## DESIGN AND HISTORIC REVIEW COMMISSION – July 20, 2017 STAFF REPORT

APPLICATION TYPE:	CASE:
River Corridor Review / Certificate of Appropriateness	RCC17-20 / CA17-02: Roman Catholic Diocese of San Angelo

APPLICATION TYPE:	CASE:
River Corridor Review	RCC 17-21: Chapa

APPLICATION TYPE:	CASE:
River Corridor Approval/Certificate of Appropriateness	RCC17-17: Gregonis & CA17-01: Post

EXISTING DOORS AND WINDOWS 220-A N. CHADBOURNE STREET (NEW DOOR AND WINDOWS TO MATCH)

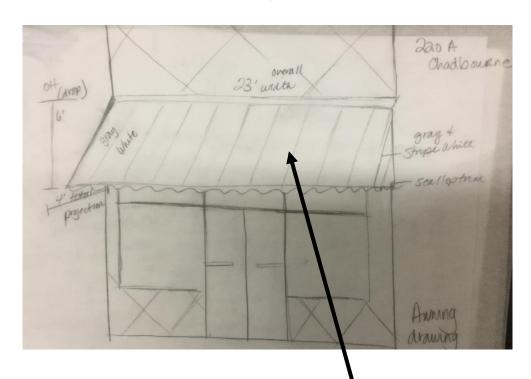
Planning Staff is concerned with the lack of architectural variation along the main façade. All of the other buildings on this block provide a greater diversity in façade design utilizing at least two different building materials (e.g. brick and stone), ornamental features, or material patterns. Although the applicant's proposed new canopy, door, and window will assist in breaking the large stucco wall expanse, Staff does not believe this goes far enough, and if approved, could set a negative precedent. Staff communicate these concerns to the applicant but the applicant had indicated plans to maintain the current proposal at this time.

The RCMDP clearly states that "each building should have a well-designed base, middle and top. Architectural detailing or a change of materials or color at the ground level may be used to create the base. The different parts of a building's façade should be emphasized by use of color, arrangement of façade elements, or a change of materials." "Materials such as stone, brick, or precast concrete, cast stone, and architectural metals can be combined to enrich the appearance of the building and highlight specific architectural features." The applicant has chosen to leave the existing stucco wall as-is with no additional articulation. Not only is this stucco not the original building material used, but it takes up the complete wall. Therefore Staff has recommended that the applicant add stone along the first story, consistent with the property immediately north in which the applicant also owns. Staff also recommends, as a condition of approval, that the applicant either continues the existing stone along the building's first story, consistent with the properties immediately north and south, or restores the original brick façade along this portion of the building. Staff believes leaving a blank wall with no material differentiation is inconsistent with the above policies and the historical character of downtown San Angelo.

- The applicant shall install a stone veneer along the building's first story, consistent with the
  properties immediately north and south or restore the original brick façade along this portion of
  the building. The applicant shall submit a revised elevation rendering to the Planning and
  Development Services Director delineating either stone or brick on these portions of the
  building.
- The colors and materials of all items shall be consistent with the renderings approved by the Design and Historic Review Commission, and as revised by the Planning and Development Services Director.
- 3. The applicant shall obtain a Building Permit for all improvements as required.
- 4. The applicant shall obtain a Right-Of-Way Encroachment approval from City Council for the canopy which encroaches into the public right-of-way.

## PROPOSED REMODELING

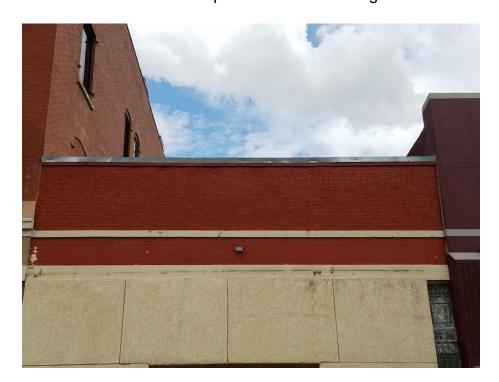
The RCDMP states that "new buildings should reflect the characteristic rhythm of existing facades along the street." While this is not a "new" building, the update to the façade will allow the characteristic rhythm to continue and will create a cohesive appearance to the conjoined buildings.

The RCDMP also states that "Patterns and rhythms in the façade of the building can be created with...changes of materials and other architectural features." Staff believes that this is important for any business in the Downtown area and the River Corridor, but especially vital in buildings that have a historic designation. An effective way to continue the pattern and rhythm would be for the developer to continue the dentil moulding found on the building located adjacent at One East Twohig to this construction. Continuation of the dentil moulding would create a pattern that is reflective of historic design elements and would allow the transition from one building to the other to be graceful. The building undergoing a façade renovation is a Historically Designated building. As such, the property is subject to not only River Corridor Approval, but also a Certificate of Appropriateness. Staff believes that the continuation of the dentil mouldings will serve to effectively give the reconstruction the additional quality and attention to detail that will allow the Certificate of Appropriateness to be approved.

The RCMDP policies state that "quality finished materials should be used." The applicant is proposing to use a four-part stucco process for the exterior called "Exterior Finish Insulating System or EFIS. The color and stucco will be consistent with the adjacent building. The new windows and doors will have bronze tinted glass and bronze colored trim that well also match the adjacent building. When the construction is complete the façade will match that at One East Twohig. The orange coloration of the adjacent building is already carried through to the subject building and the applicant is leaving that strip of color which will serve to further tie the buildings together.

Staff's recommendation is for the Design and Historic Review Commission to APPROVE the Certificate of Appropriateness and APPROVE the River Corridor Review for the construction for a new building façade for the property located at 202 South Chadbourne Street.
